### **REMARKS**

Amendments to the Drawings:

**FIG. 1**

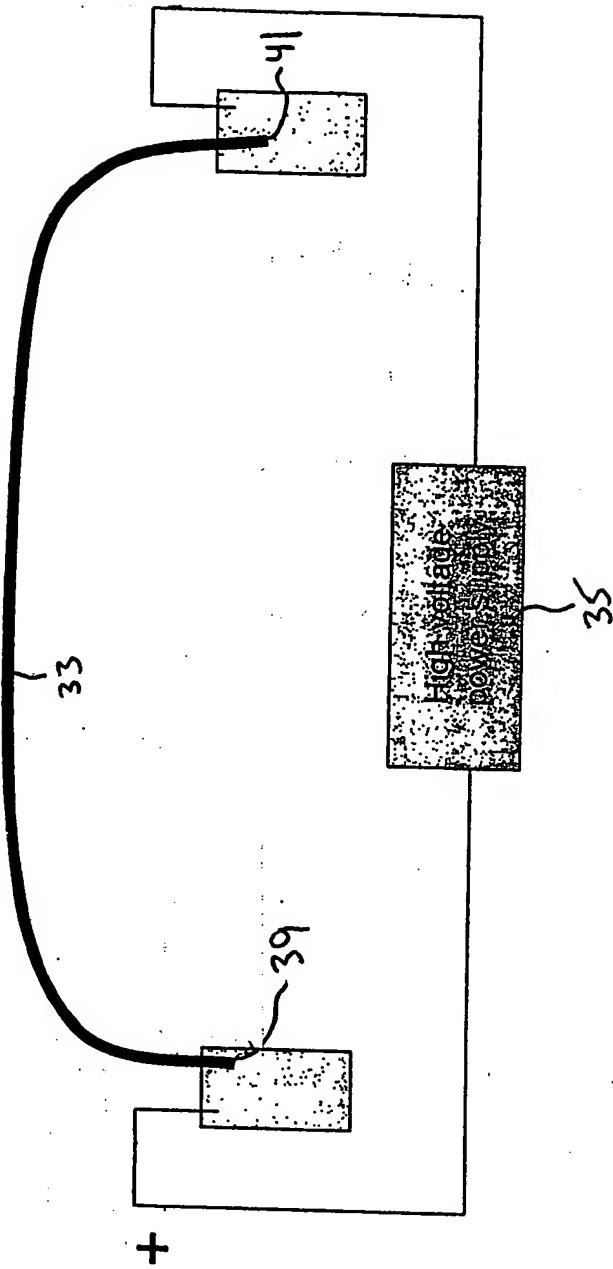
The August 5, 2004 Office Action objected to FIGS. 1 and 2, stating:

Figures 1 and 2 should be designated by a legend such as --Prior Art--because only that which is old is illustrated. See MPEP § 608.02(g). Corrected drawing sheets are required in reply to the Office action to avoid abandonment of the application. The replacement sheet(s) should be labeled "Replacement Sheet" in the page header (as per 37 CFR 1.84(c)) so as not to obstruct any portion of the drawing figures. If the changes are not accepted by the examiner, the applicant will be notified and informed of any required corrective action in the next Office action. The objection to the drawings will not be held in abeyance. (August 5, 2004 Office Action; Page 2).

With this Response, FIGS. 1 and 2 have been amended to include the legend "Prior Art." Please find enclosed: Replacement Sheet displaying FIG. 1, Replacement Sheet displaying FIG. 2, a sheet illustrating the changes made to originally filed FIG. 1 (changes shown in red), a sheet illustrating the changes made to originally filed FIG. 2 (changes shown in red), and Applicant has resubmitted original FIGS. 3-7 (for completeness). As such, Applicant respectfully requests that the objection to the drawings be withdrawn.

Sheet 1, which includes FIG. 1, replaces the sheet that includes FIG. 1.
